4th Session SEISMIC EFFICIENCY OF LARGE STRUCTURES (RECOMMEN DATIONS, CHECKING AND SURVEILLANCE)

#### DISCUSSION

Paper 4/1 R. PRISCU, A. POPOVICI, C. STERE - ROMANIA

"The Consequences of Partially Grouted Joints Upon the Arch
Dam Seismic Behaviour"

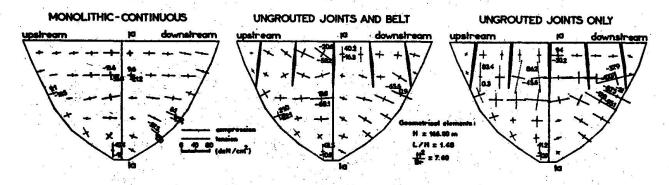
I believe that the ordinates of fig. 4 are all ten times too large and a decimal point should be added; also in fig. 7 I find it difficult to understand the large horizontal stresses in the area where the joints are ungrouted.

The values of the velocity potential function  $\psi$  presented in figure 3 are correctly represented. This fact could be properly noticed by making an analogy with the classical relationship of Westergaard. Let us consider for instance the network point (i) of the dam central cross-section, situated at the depth  $4 \cdot \Delta$  z = 132 m below the crest, whereat the potential function is  $\psi$  i = 99.6 m.

The specific added mass normally directed to the dam upstream face comes out to be:

$$m_{hi} = g \cdot \Psi_i = 0.102 \times 99.6 = 10.15 \text{ tf. s}^2/\text{m}^3$$
 (1)

If, in the foreconsidered point (i), an acceleration of 0.1 g  $\approx$  1 m/s<sup>2</sup> normally directed to the dam surface (c<sub>ni</sub>) is being taken into consideration the hydrodynamic pressure will be:

$$p_{hi} = m_{hi} \cdot c_{ni} = 10.15 \times 1 = 10.15 \text{ tf/m}^2$$
 (2)

One comparatively gives the same hydrodynamic pressure by using in stead the Westergaard relationship, with the same above data:

$$p_{hi} = a_{ni} \cdot C_{p} \cdot \sqrt{H \cdot z_{i}} = 0.1 \times 0.9 \cdot \sqrt{165 \times 132} = 13.20 \text{ tf/m}^2$$
 (3)

However, the values of the potential function take into consideration the dam and valley (reservoir) geometry and the earthquake wave direction.
